**ADDENDUM TO THE  
FINAL DRAINAGE REPORT  
FOR  
HOMESTEAD AT STERLING RANCH FILING NO. 2

EPCD File No. SF-19-004/CDR-20-012**

**June 16, 2021  
Project No. 25188.00**

**Prepared By:  
JR Engineering, LLC  
5475 Tech Center Drive, Suite 235  
Colorado Springs, CO 80919  
719-593-2593**

PROPOSED DRAINAGE MAP (ADDENDUM)  
 HOMESTEAD AT STERLING RANCH FILING NO. 2  
 JOB NO. 25188.00  
 03/23/2021  
 SHEET 1 OF 1

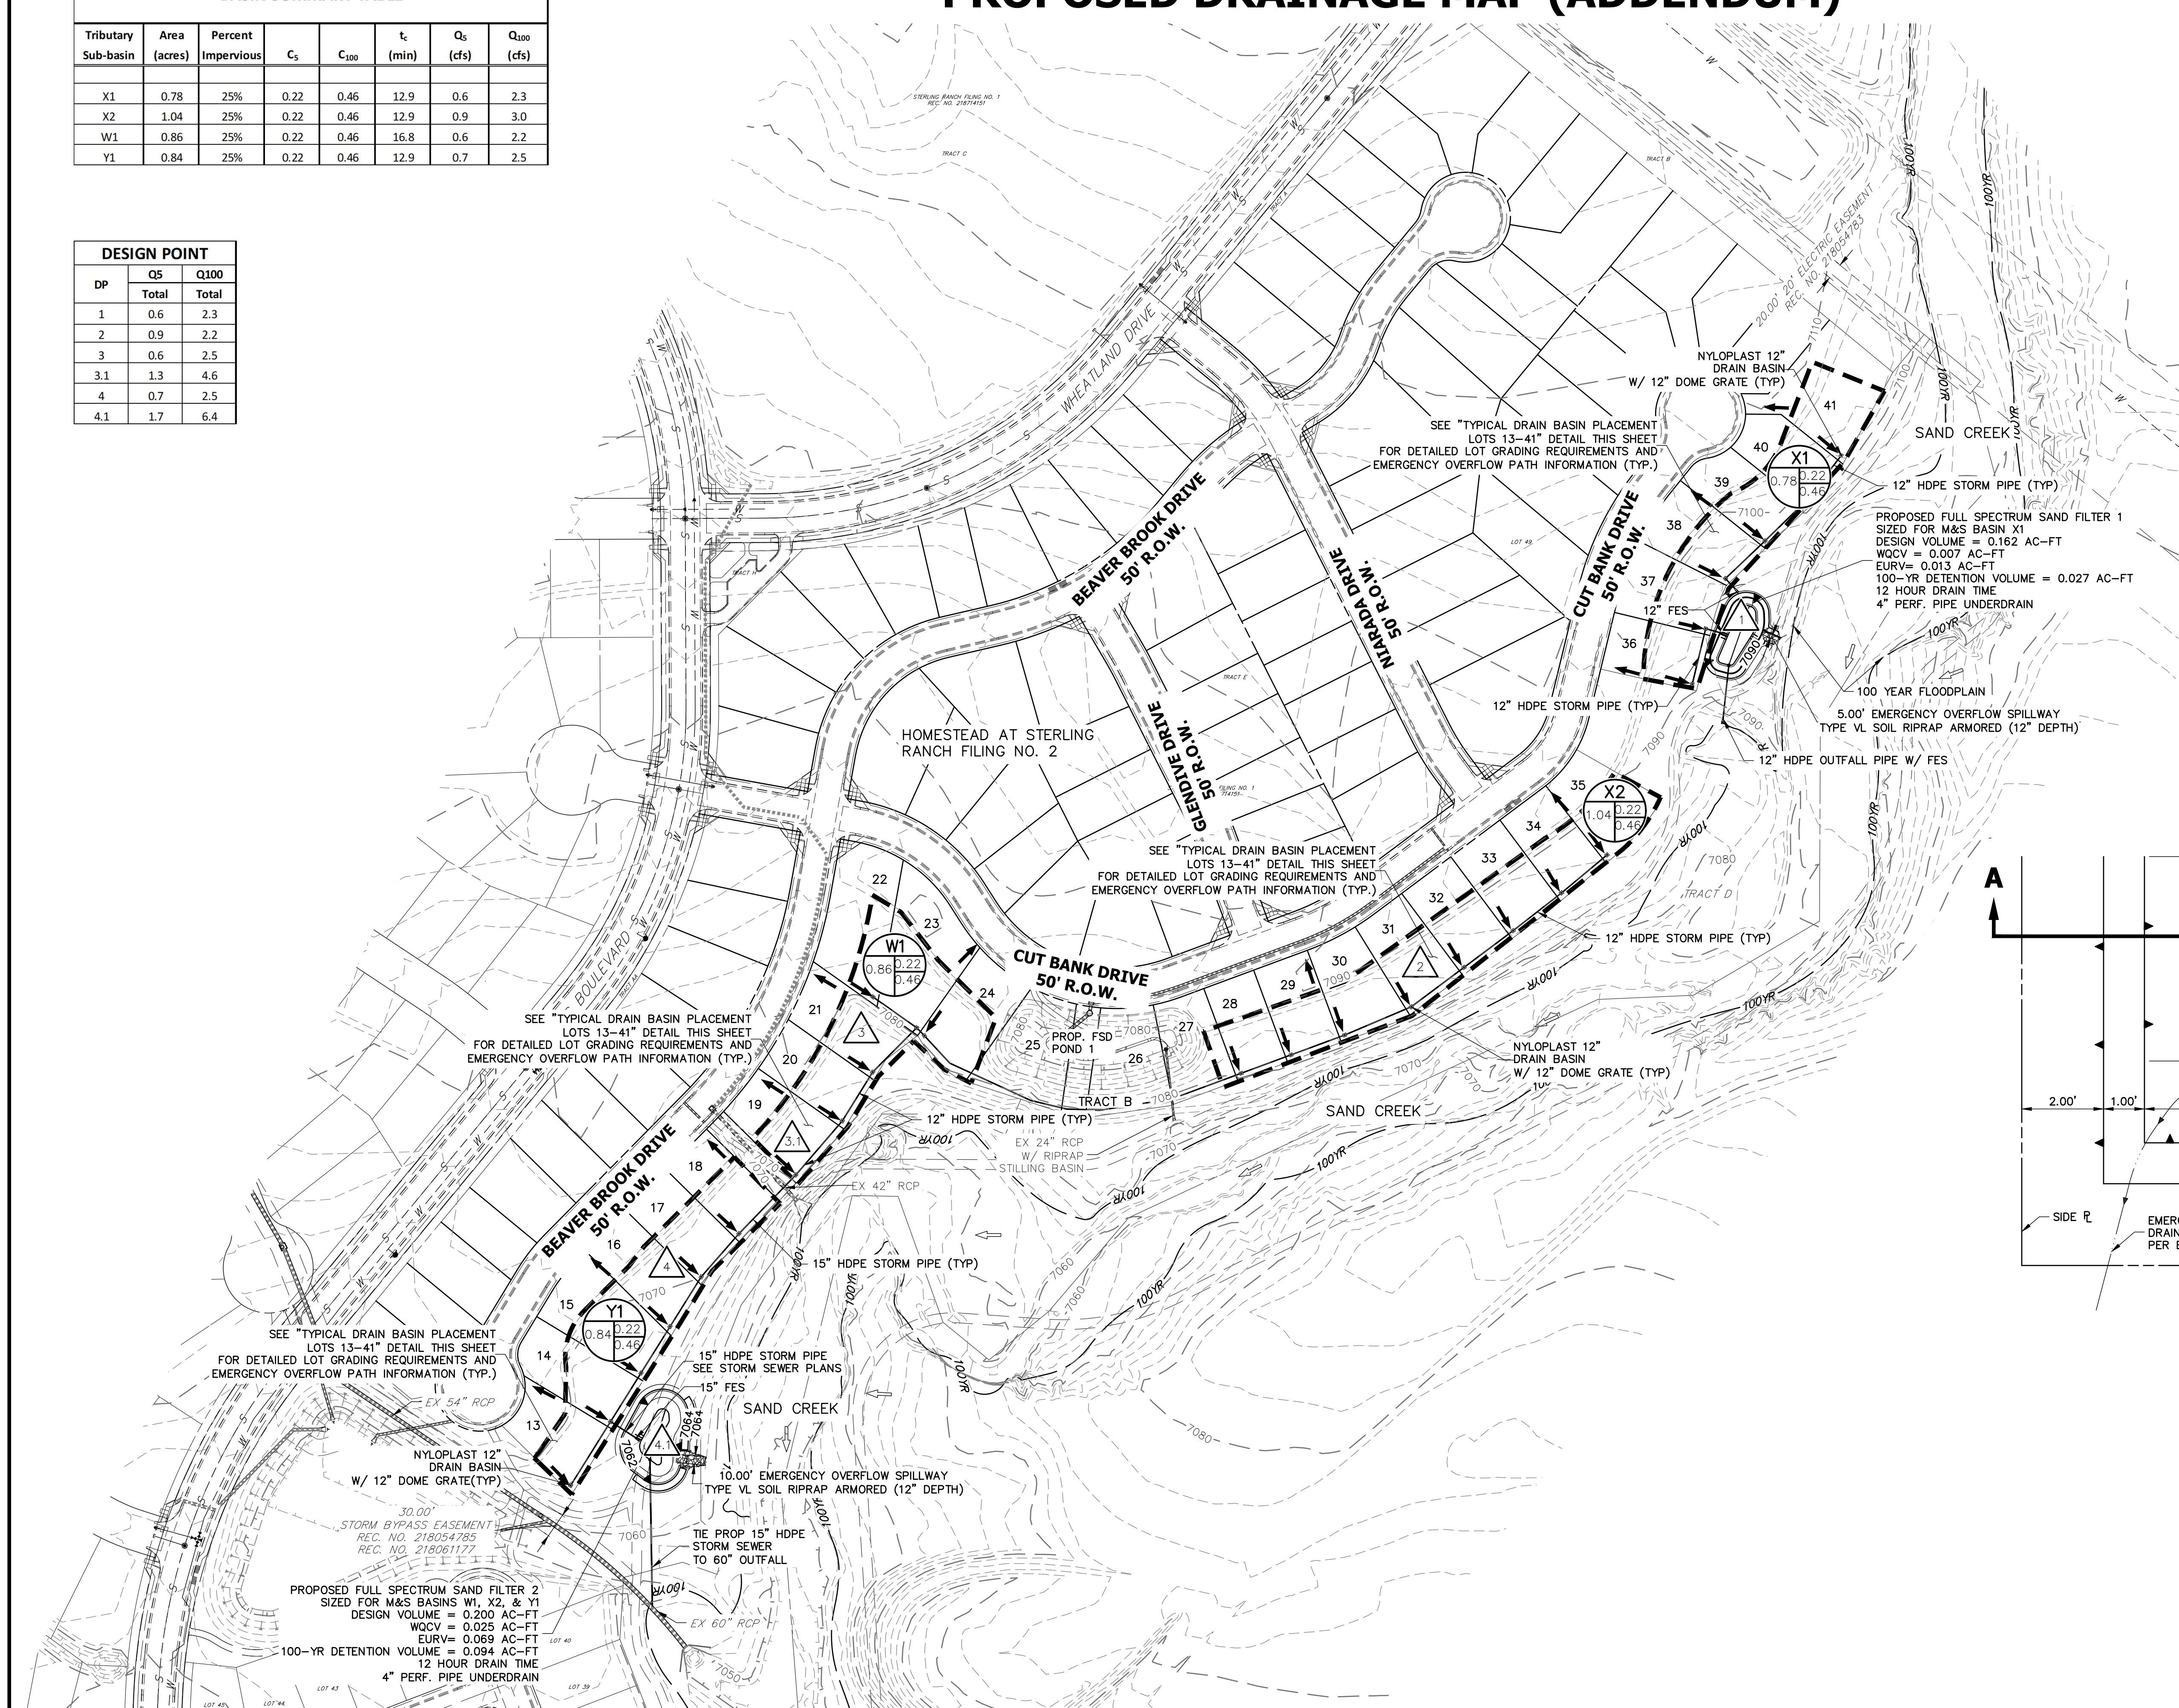
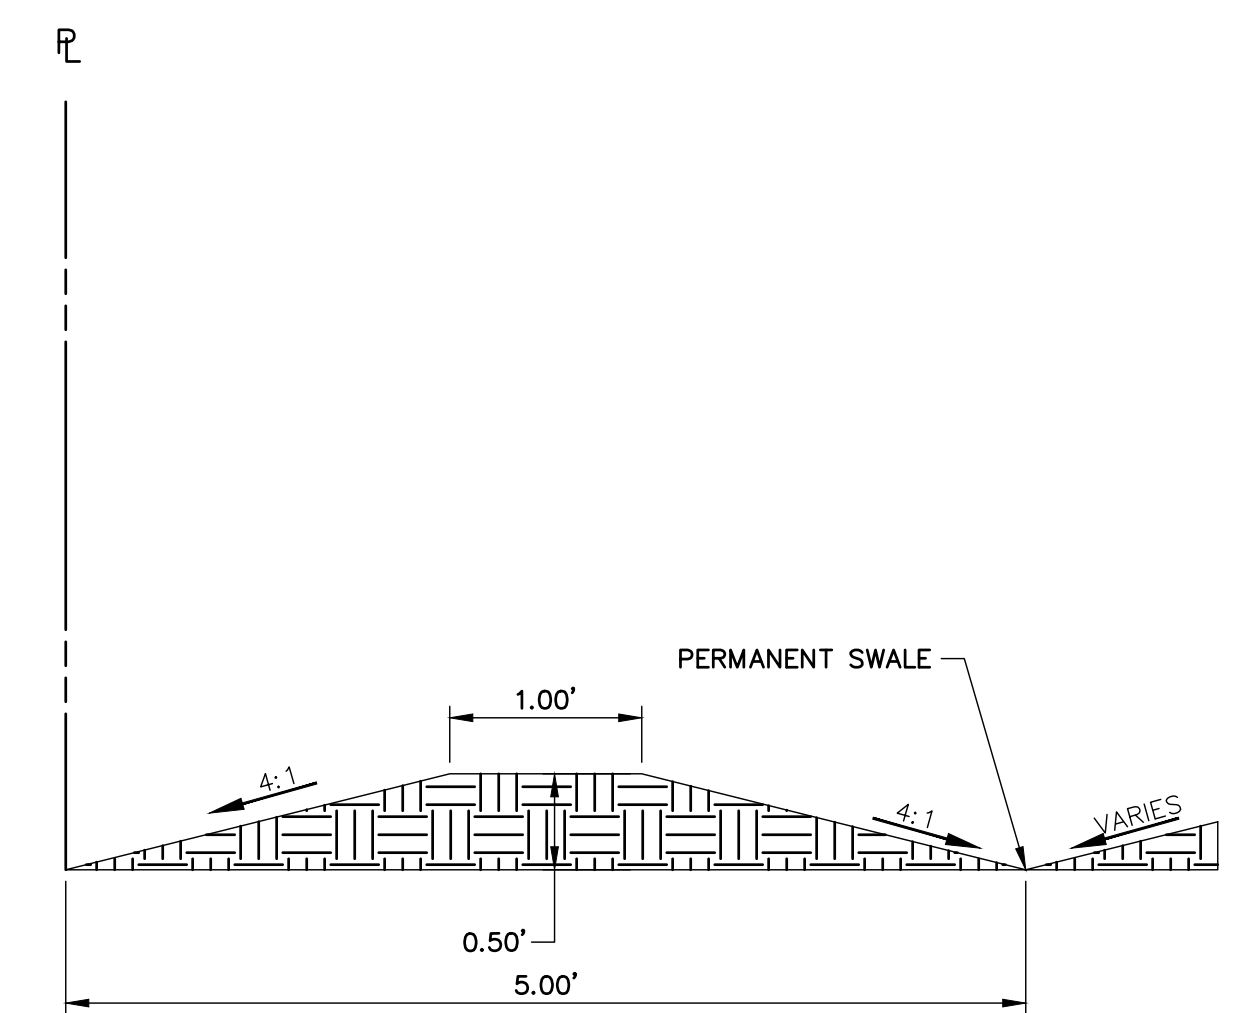
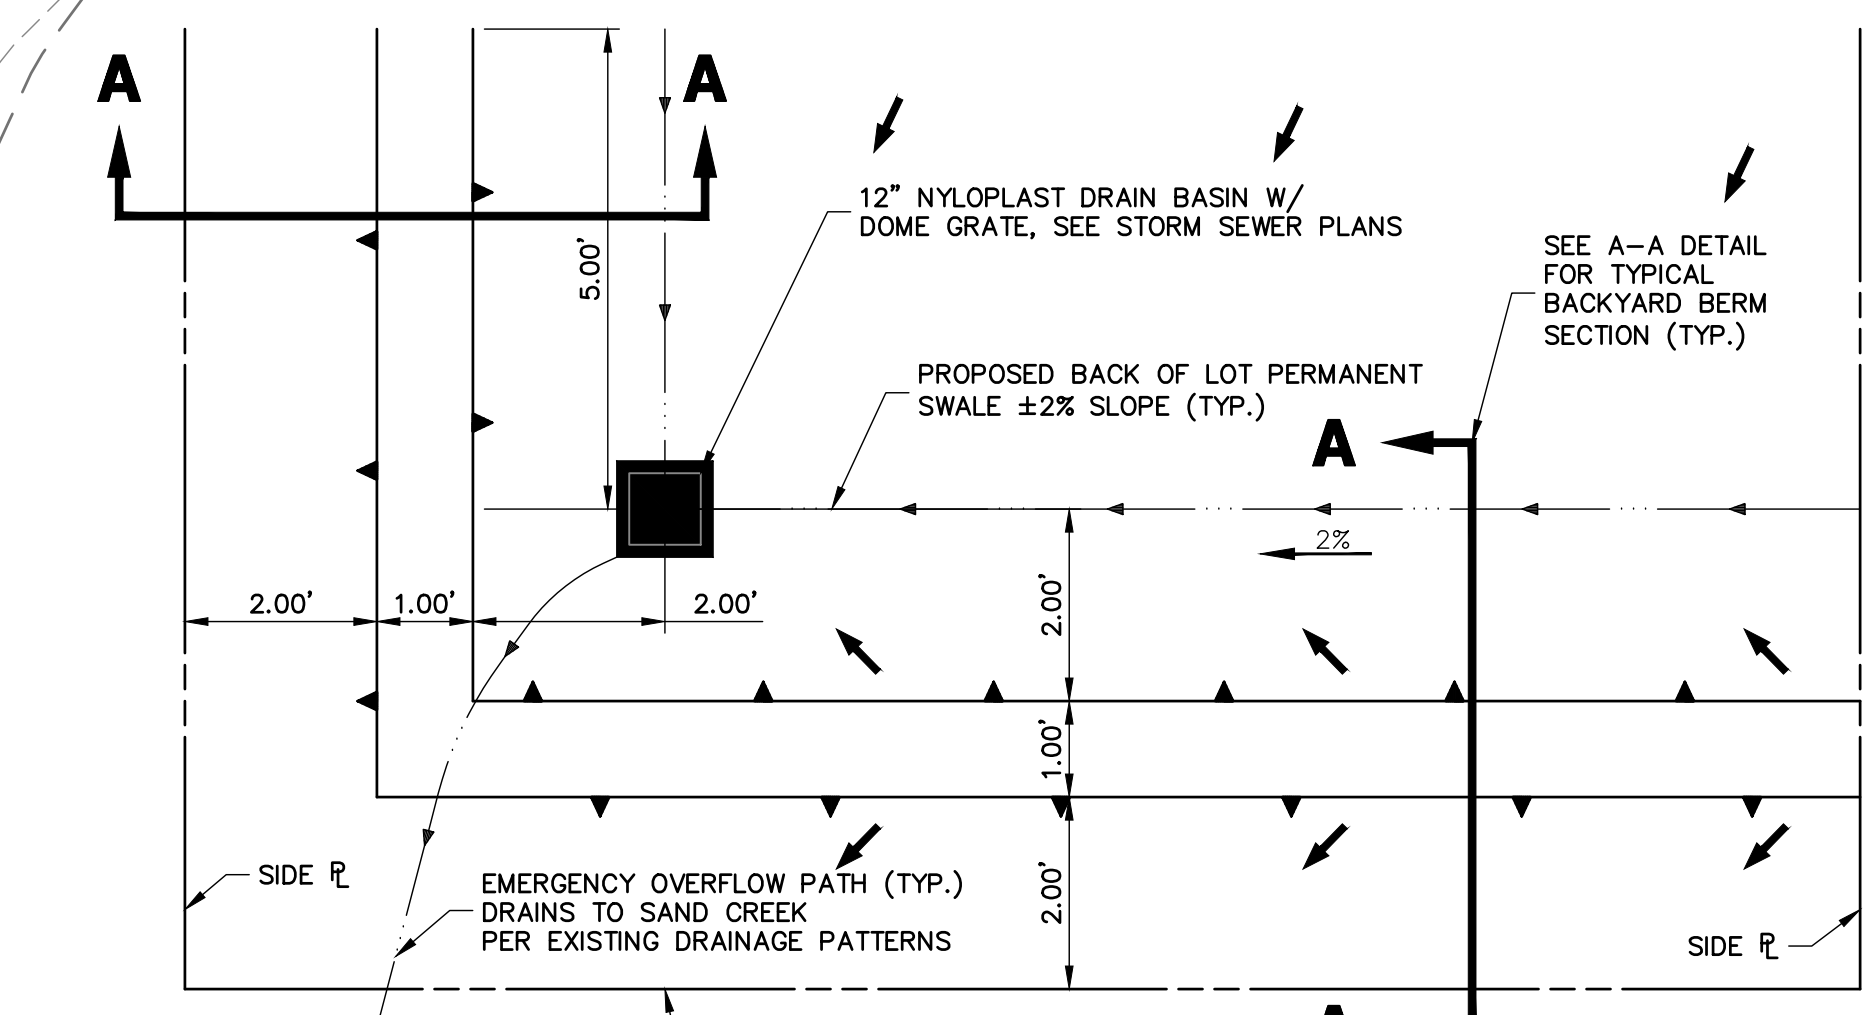
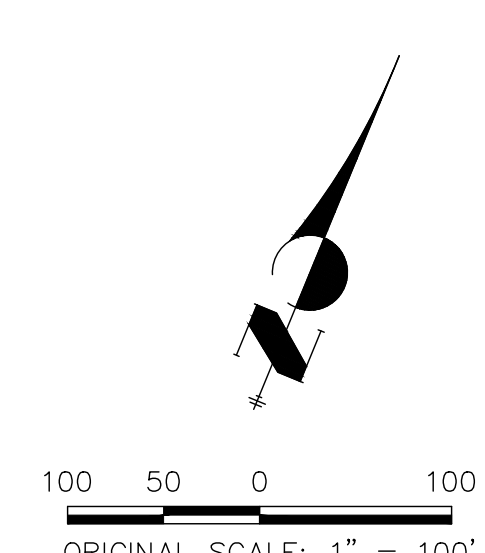
This document is an Addendum to the Final Drainage Report for Homestead at Sterling Ranch Filing No. 2. The purpose of this report is to update the approved “Final Drainage Report for Homestead at Sterling Ranch Filing No. 2”. The scope of the updates included in this addendum are limited to proposed Basins W1, X1, X2, & Y1. More specifically, this Addendum proposes to replace the proposed individual lot Sand Filters for lots 13-24, 28-35, and 36-41 with two common Sand Filters, one to serve basin X1, lots 36-41, and one to serve basins W1, X2, & Y1, lots 13-24 & 28-35.

The basin characteristics, hydrologic parameters, runoff and rational calcs for Basins X1, X2, W1, and Y1 have remained consistent with the approved Final Drainage Report for Homestead at Sterling Ranch Filing No. 2. However, the routing of the basins has changed and therefore revised SF-2 & SF-3 forms are included in the appendix section of this report. A revised basin map, showing the changes within the above described basins is also attached to this report.

**BASIN X1** (0.78 acres), consists of proposed residential backyards of lots 36-41 along the eastern boundary of the site with runoff coefficients of 0.22 for the 5 year and 0.46 for the 100 year. Runoff in this basin will be directed via backyard swales/berms towards the rear of the lots where it will be collected in a 12” Nyoplast Drain Basin w/ a 12” dome grate placed in the rear southwest corner of each lot. Each lot will have a half foot berm/swale along the rear and low side of lot that directs water to each inlet, see the detail included on the drainage map, GESD, and Storm plans. Should the inlet in any lot become clogged, the berm will overtop, and flow will continue to Sand Creek. Per the original drainage report by MandS, the estimated flows per each lot in basin X1 = 0.2 cfs for the 100 year storm. The 12” Nyoplast Drain Basins are sized to collect all flows ( $Q_5 = 0.6$  cfs,  $Q_{100} = 2.3$  cfs) in both the 5 and 100 year storms. Collected flows will then be piped to a proposed full-spectrum sand filter, with a 12-hour drain time and a 4” perforated underdrain. The treated flows from the sand filter will be discharged via an outlet structure to the adjacent Sand Creek.

**BASIN X2** (1.04 acres), consists of proposed residential backyards of lots 28-35 along the southern boundary of the site with runoff coefficients of 0.22 for the 5 year and 0.46 for the 100 year. Runoff in this basin will be directed via backyard swales/berm towards the rear of the lots where it will be collected in a 12” Nyoplast Drain Basin w/ a 12” dome grate placed in the rear southwest corner of each lot (DP2). Each lot will have a half foot berm/swale along the rear and low side of lot that directs water to each inlet, see the detail included on the drainage map, GESD, and Storm plans. Should the inlet in any lot become clogged, the berm will overtop, and flow will continue to Sand Creek, per existing drainage patterns. The 12” Nyoplast Drain Basins are sized to collect all flows

**BASIN Y1** (0.84 acres), consists of proposed residential backyards of lots 13-18 along the southeastern boundary of the site with runoff coefficients of 0.22 for the 5 year and 0.46 for the 100 year. Runoff in this basin will be directed via backyard swales towards the rear of the lots where it will be collected in a 12" Nyoplast Drain Basin w/ a 12" dome grate placed in the rear corner of each lot (DP4). Each lot will have a half foot berm/swale along the rear and low side of lot that directs water to each inlet, see the detail included on the drainage map, GESC, and Storm plans. Should the inlet in any lot become clogged, the berm will overtop, and flow will continue to Sand Creek per existing drainage patterns. The 12" Nyoplast Drain Basins are sized to collect all flows (Q5 = 0.7 cfs, Q100 = 2.5 cfs) in both the 5 and 100 year storms. Collected flows will then be piped southwest via 12" HDPE pipe following the rear lot lines to a proposed full spectrum sand filter at DP4.1, where flows combine with collected flows from Basin X2 and W1 (Q5 = 1.7 cfs, Q100 = 6.4 cfs).
